# CATHERINE FIELD (PART) PRECINCT PEER REVIEW WATER CYCLE MANAGEMENT & FLOODING

Prepared for:  
**DEPARTMENT OF PLANNING &  
INFRASTRUCTURE**

March, 2013

Prepared by:  
**J. WYNDHAM PRINCE**  
CONSULTING CIVIL INFRASTRUCTURE ENGINEERS  
& PROJECT MANAGERS

**Terrain Difference Map  
 Brown Terrain - WMA Water  
 Terrain**

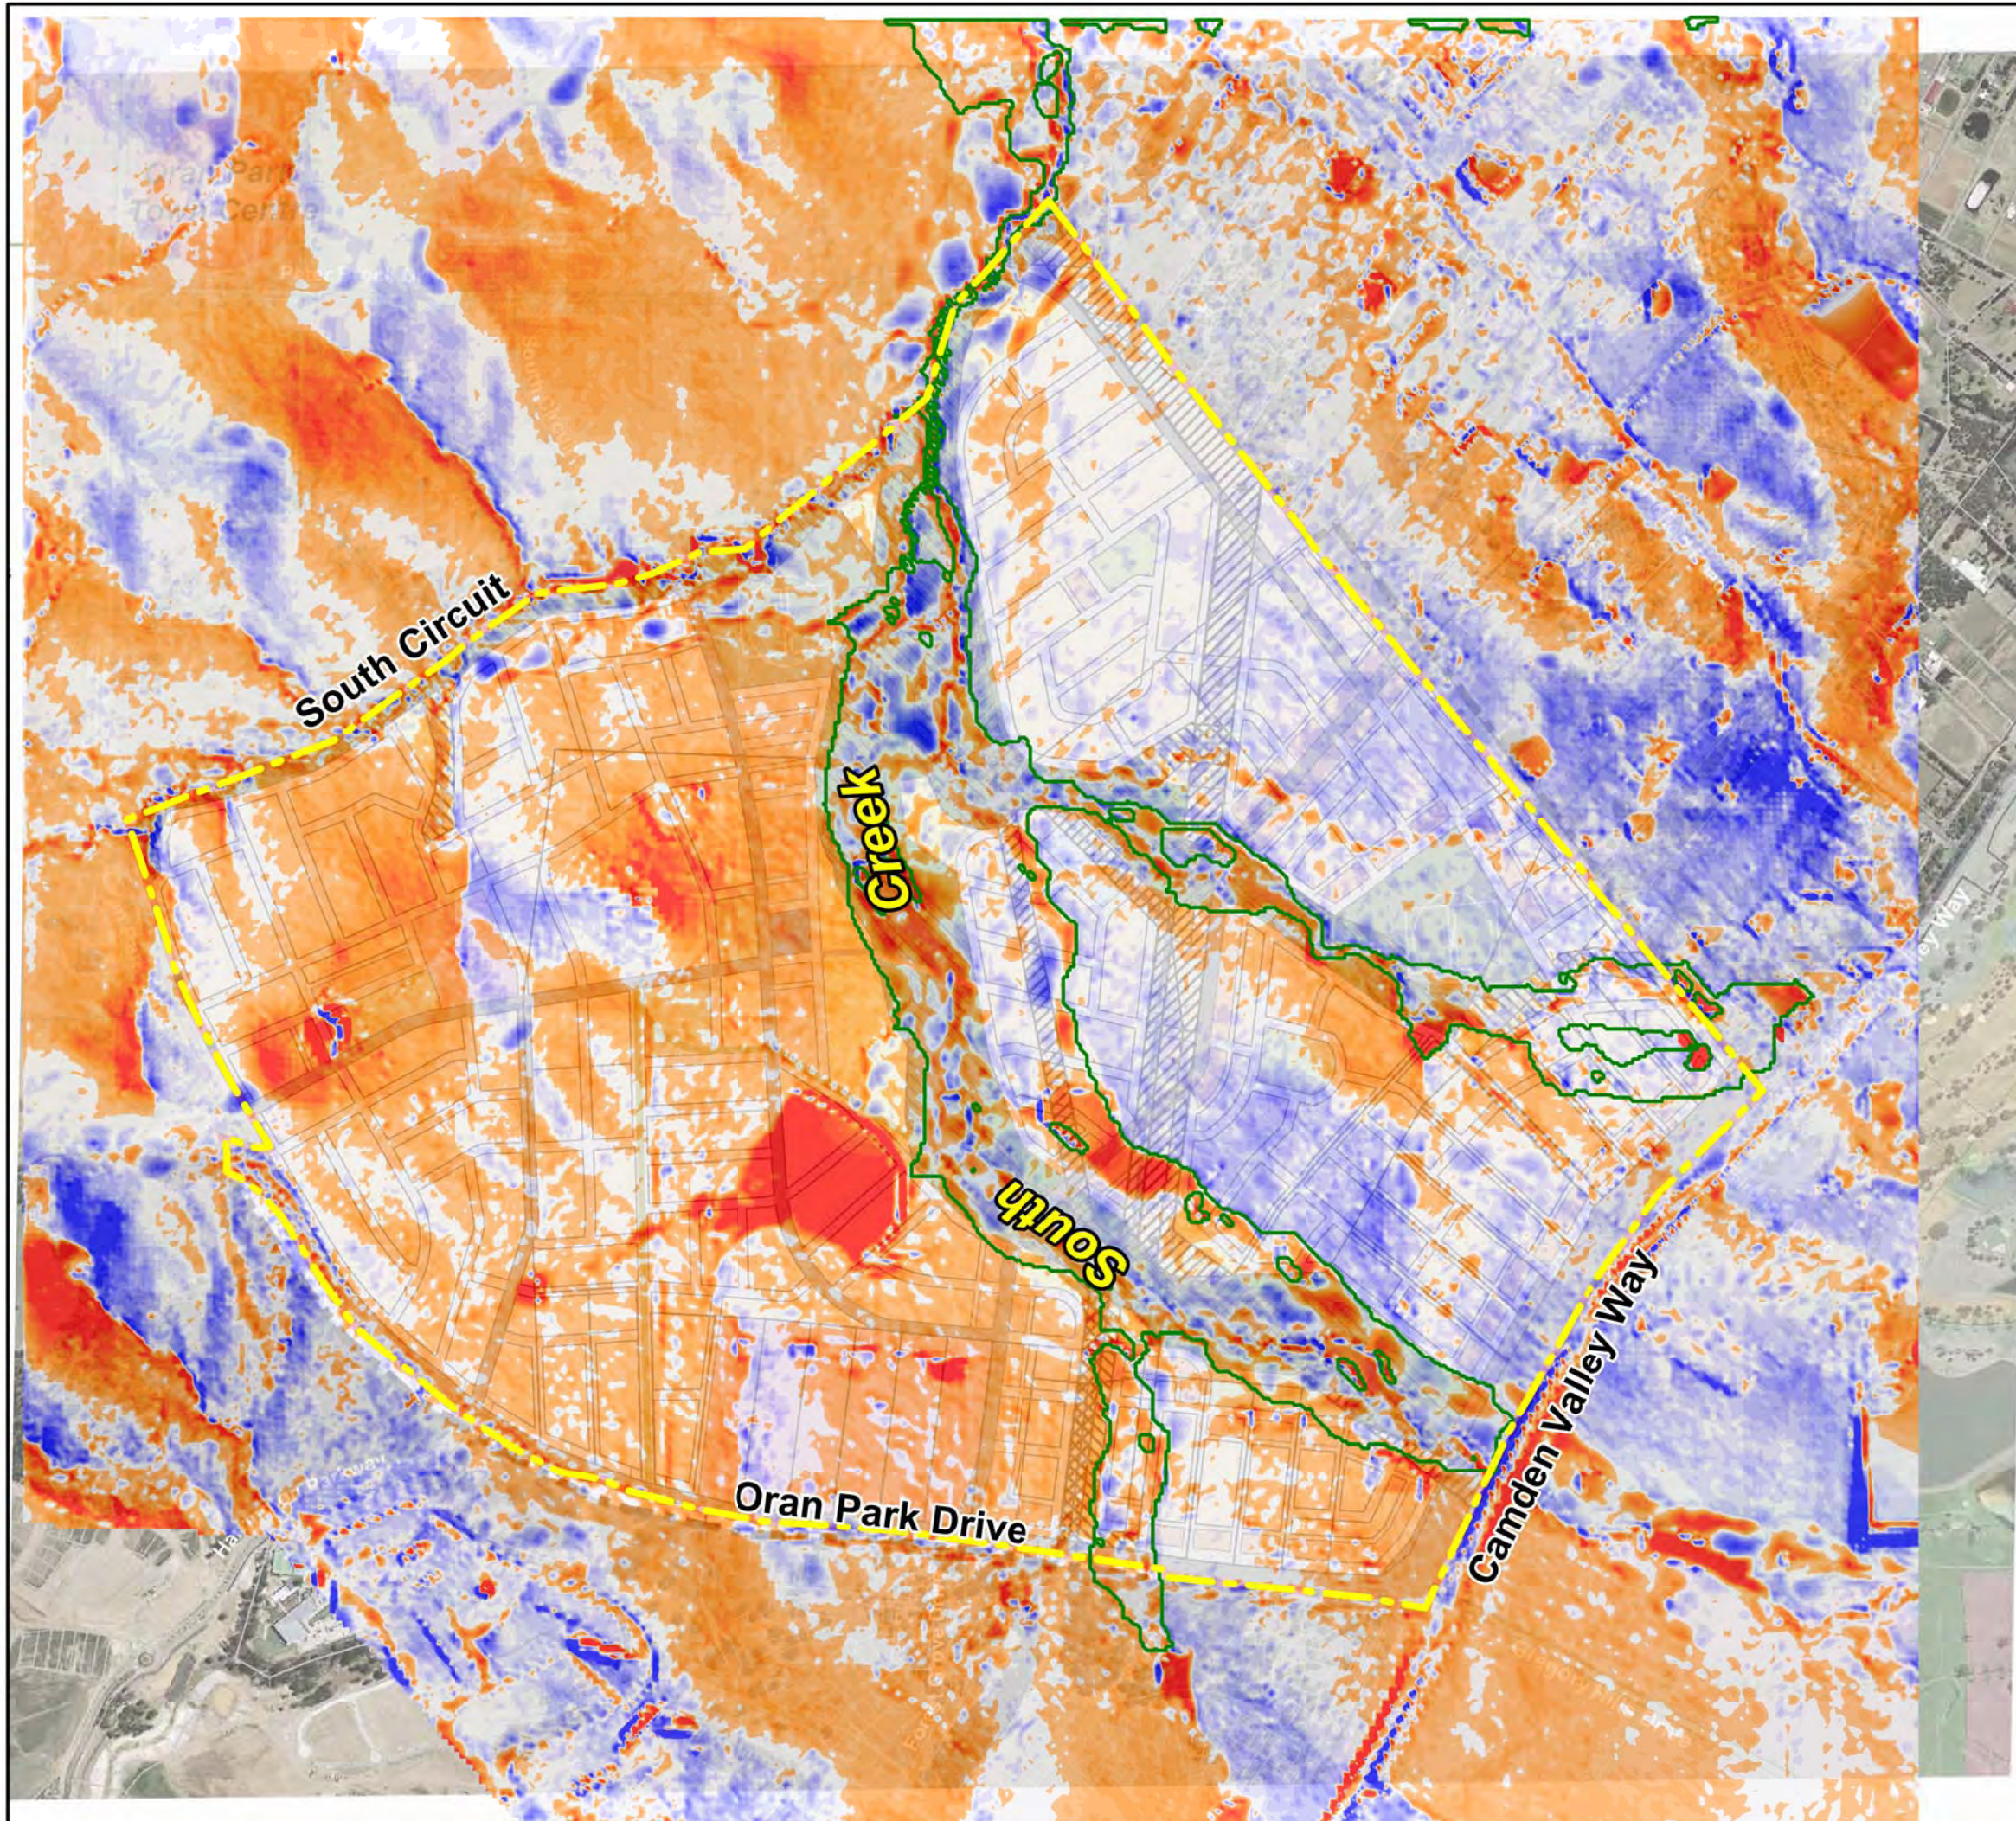
The terrain difference mapping (Figure 1) shows that levels in the existing case surfaces do vary between the two models within the floodplain extents. There is a relatively even distribution of higher and lower terrain levels in the Brown surface. Levels also vary outside the floodplain extents, however will not impact on the flood modelling. It is understood that the surface used by Brown Consulting includes detail survey data, so should be to a greater level of accuracy. The surface levels between the two models (within the Brown Consulting 100 year ARI flood extents) vary by up to approximately  $\pm 400\text{mm}$ .

100 Year ARI Difference Map  
 Brown Existing - WMA Water Existing

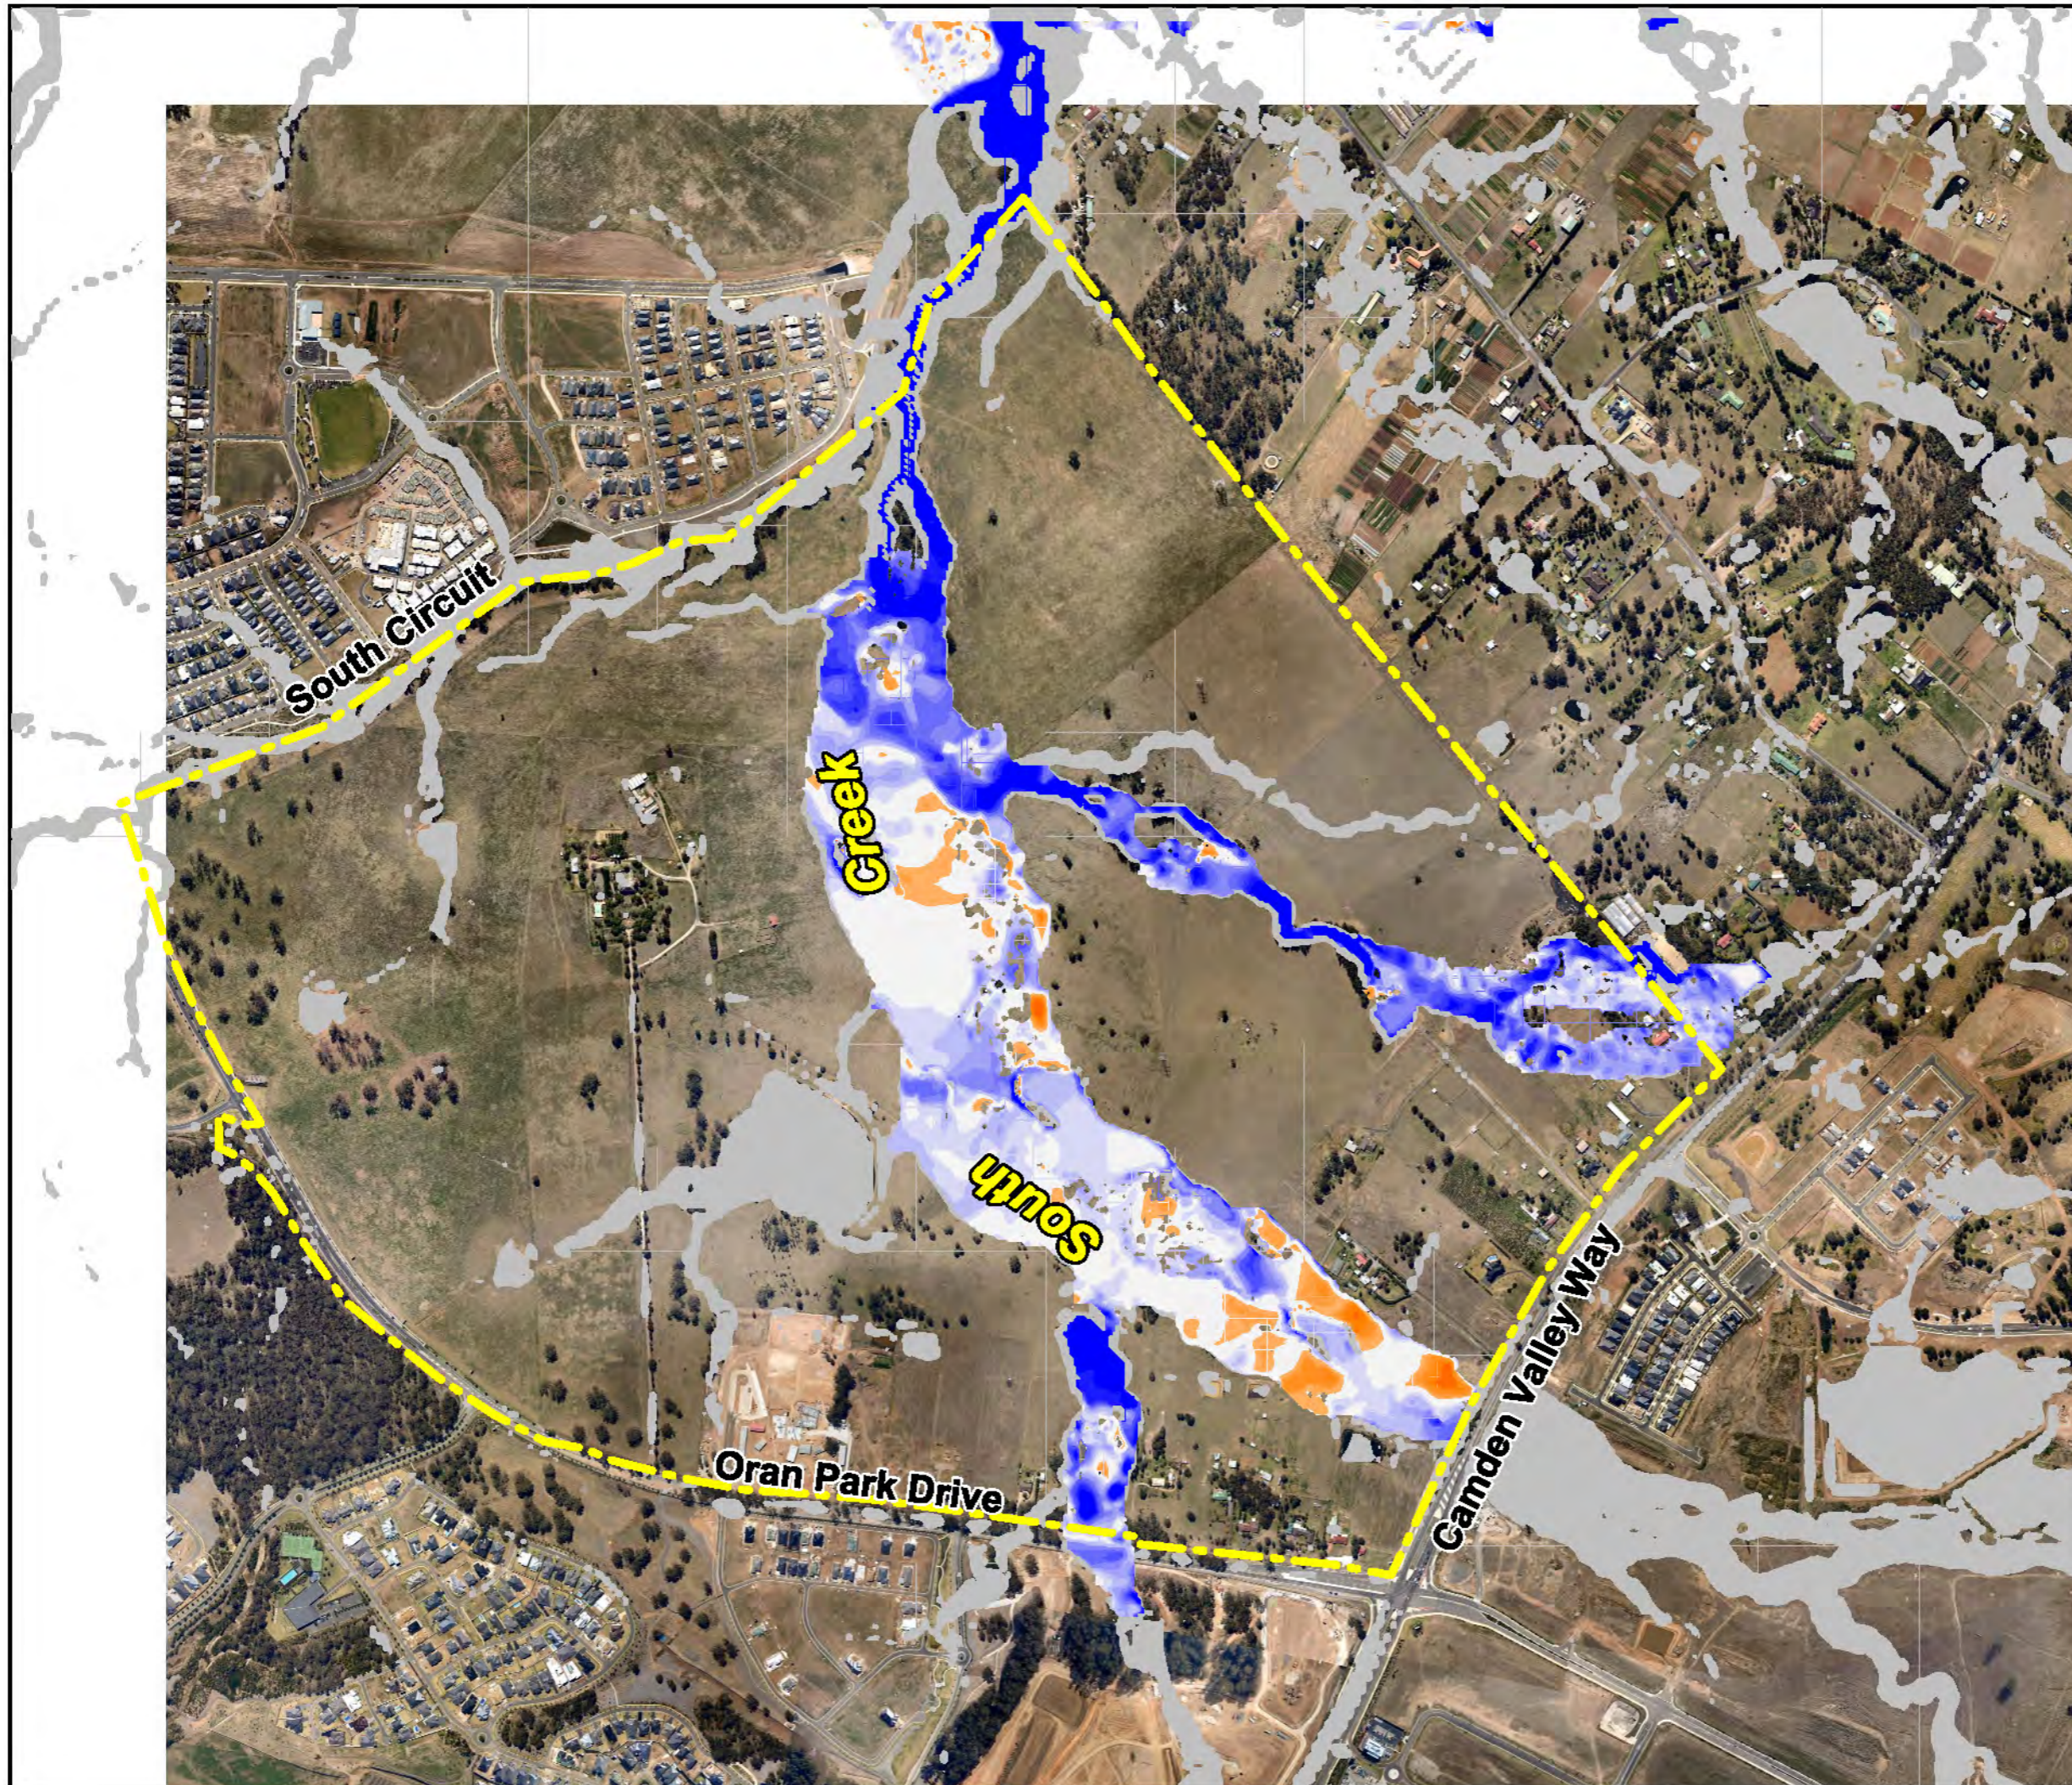
The existing case 100 year ARI flood difference mapping (Figure 2) shows that the majority of levels from the Brown modelling are the same or lower than the WMA Water levels, with some isolated areas where levels are higher. The Brown Consulting existing 100 year ARI flood levels are up to approximately 780mm lower in areas and up to approximately 240mm higher in other

areas. The difference mapping for this scenario also shows some increases in flood levels outside of the Precinct boundary.

The hydraulic assessment does not appear to include the significant extent of catchment on the western side of South Creek (see Figure 2). While this may not be an identified water course, there may be a need to provide a trunk drainage corridor to convey flows to South Creek. A post development catchment plan that correlates to the ILP has not been included, however the existing case catchment area to South Creek at this location exceeds 40 hectares.

- The need to provide a trunk drainage corridor to the west of South Creeks needs to be clarified. It is not clear whether flows from this large area can be practically or safely conveyed in the pipe and street drainage network.
